Service Bulletin No. 410

MODEL	D Series	TYPE	Field Change Program	SECTION/GROUP	8-Engine	DATE	June 4, 2014
SUBJECT	DIESEL EXHAUST FLUID PRESSURE LINE HEAT SHIELD						
CONDITIONS

Figure 2.

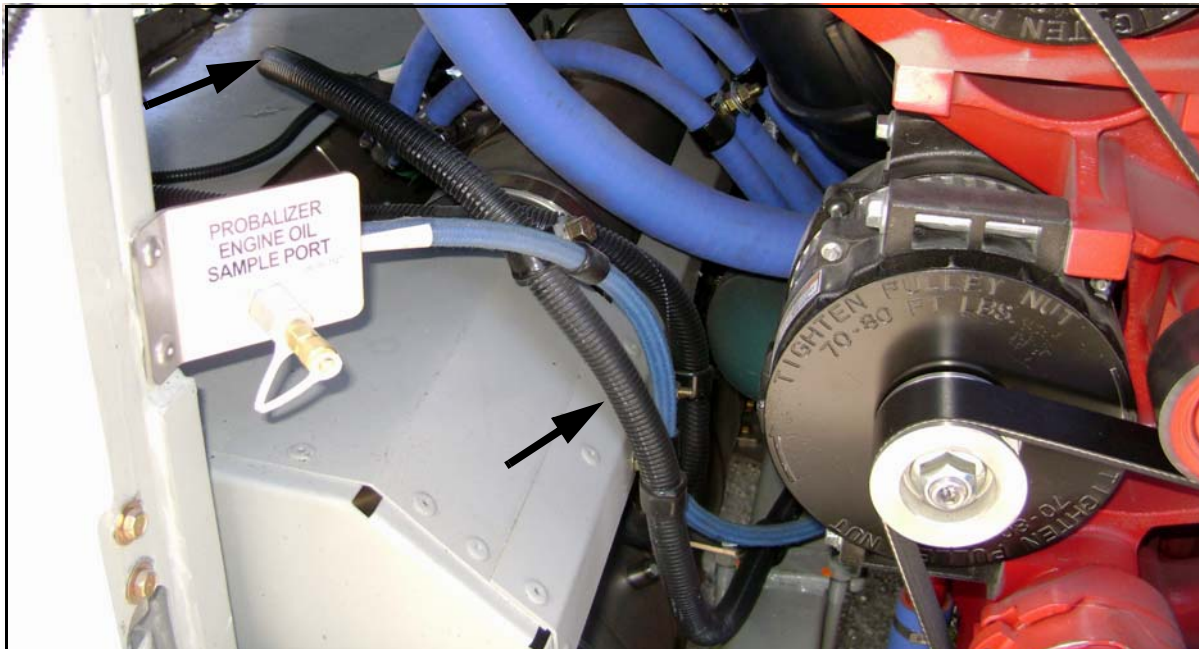
3. Enter the coach cabin and locate the engine compartment access hatch cover at the rear of the cabin. Remove and retain the hardware. Carefully lift the hatch cover and place aside to be re-installed at a later step in this procedure.
4. Open the engine compartment doors as well as the curbside, rear side service compartment door.
5. Locate the diesel exhaust fluid (DEF) pressure line in the rear, roadside section of the engine compartment (refer to Figures 2 and 3).

Figure 3.

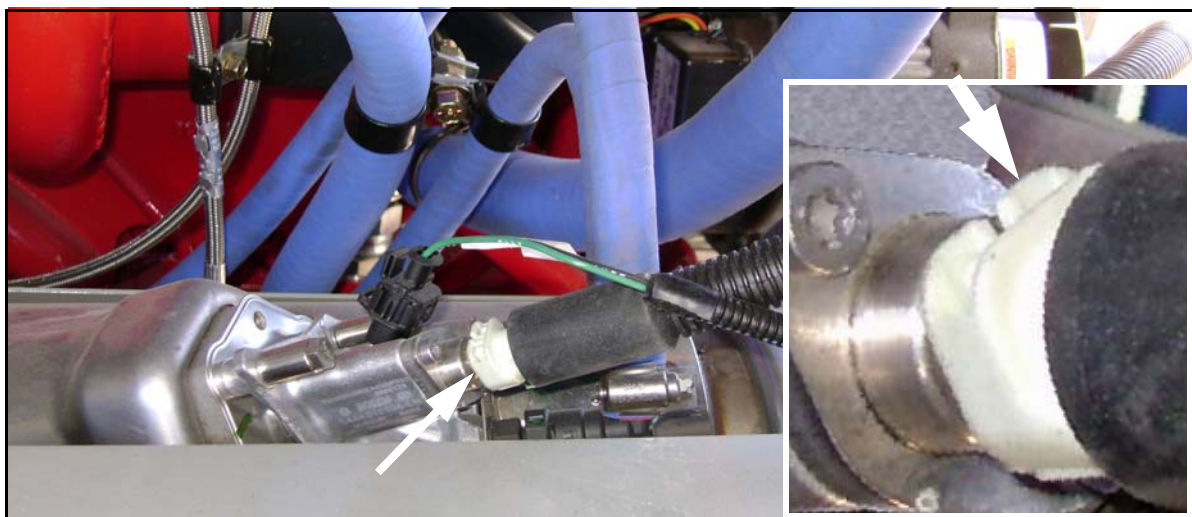
6. Follow the routing of the DEF pressure line to locate the connection at the dosing module (refer to Figure 3). Apply pressure to the button on the spring-lock connector located at the end of the DEF pressure line to release the line from the dosing module.
7. Cover the open end of the DEF pressure line as well as the doser connector to prevent contaminants from entering the system.

Figure 5.

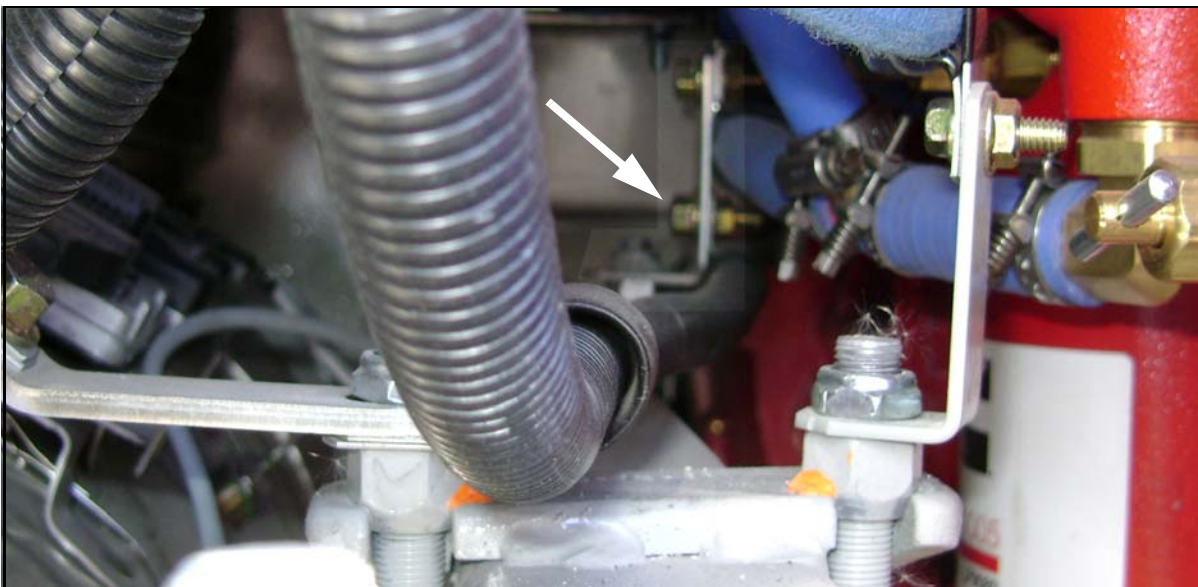
8. Follow the routing of the DEF pressure line in the engine compartment and locate the line support clamps mounted to the engine rail (refer to Figure 4 and 5). Remove and retain the two (2) line support clamps and mounting hardware shown in Figures 4 and 5.

Figure 6. View of the DEF pressure line at the rear bulkhead from the curbside, rear side service compartment

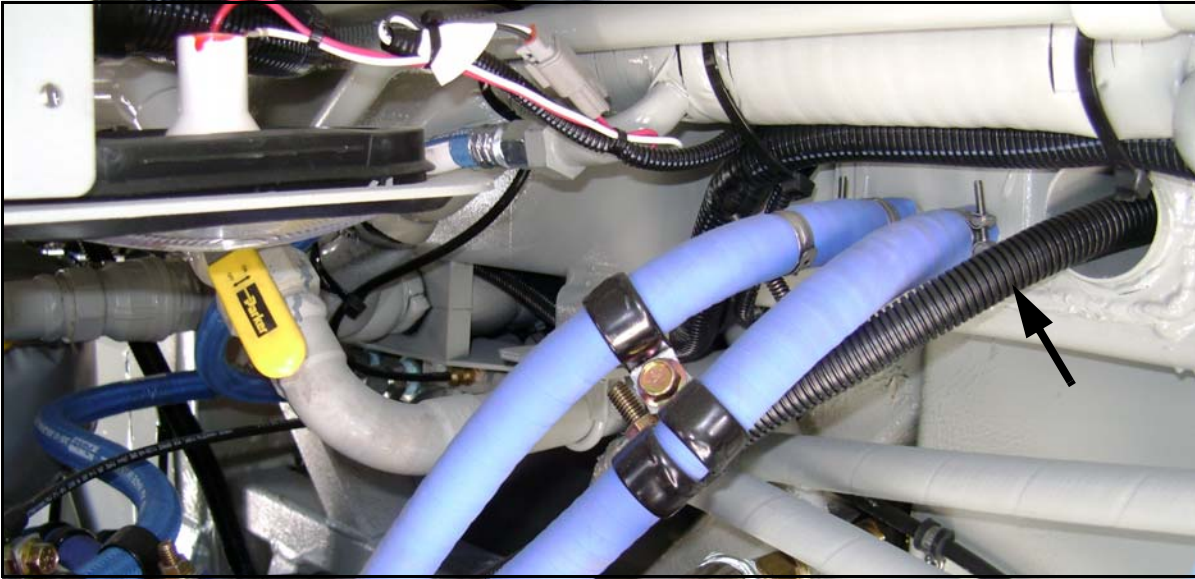
10. Enter the coach cabin and locate the DEF pressure line routing and line support clamps below the engine compartment access hatch. Remove the line support clamps mounting hardware. Retain the hardware and discard the clamps.
11. Orient one end of the heat shield, p/n 08-20-2458, over the disconnected end of the DEF pressure line (at the dosing module). Carefully route the heat shield over the line all the way back to the rear bulkhead.
